IMPORTANT SAFETY RECALL NOTICE

Gillig Campaign ID Number: 17V-156

Wiper Arm Inspection and Replacement Procedures

Version Identification – Wiper Arm Mounting Castings

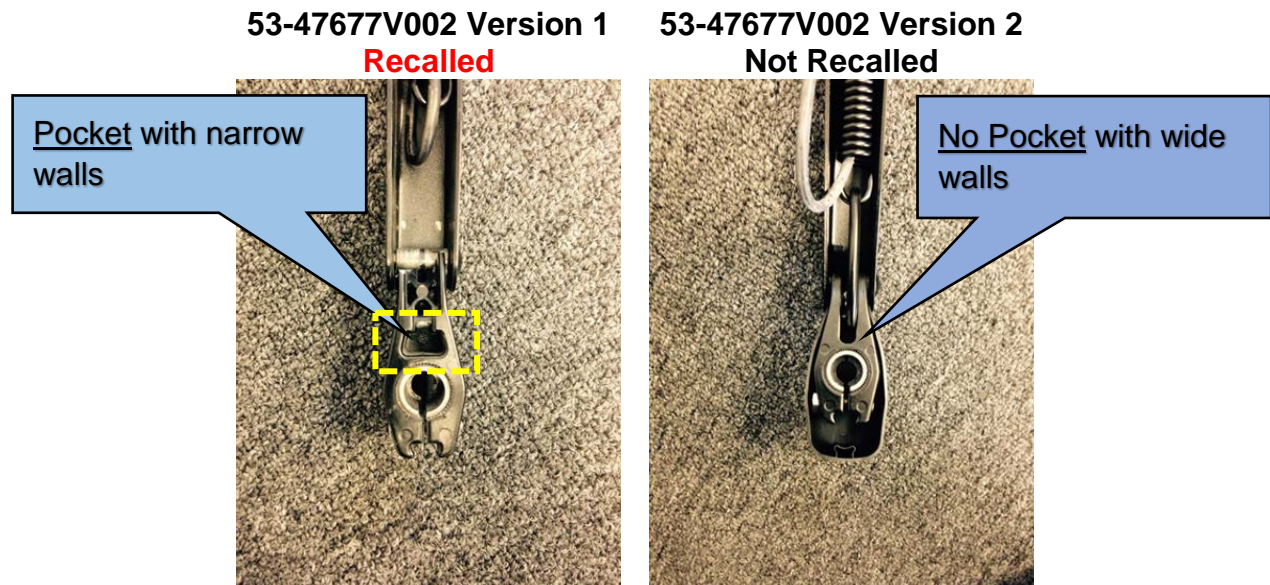
What The Issue Is: ***Certain Sprague Devices brand wiper arms (Gillig Part No. 53-47677V002, Version 1) may develop cracks in the mount casting that attaches them to the wiper motors. In some cases, the arms may bend or detach from the vehicle.***

1. Pull the wiper blade away from the windshield into the off-glass position.
2. Inspect the wiper arm mounting casting as shown below, noting the construction of the mounting casting.
3. The wiper arms being recalled (*Version 1*) can be identified by the pocket in the center of the arm and the thin wall adjacent to the pocket. See picture below.
4. Please record the number of Version 1 wiper arms identified in your inspections and submit a request for this quantity of free recall replacement parts from Gillig.

Upon reception of the *Version 2* replacement parts, please replace all *Version 1* wiper arms per the instructions in the next section.
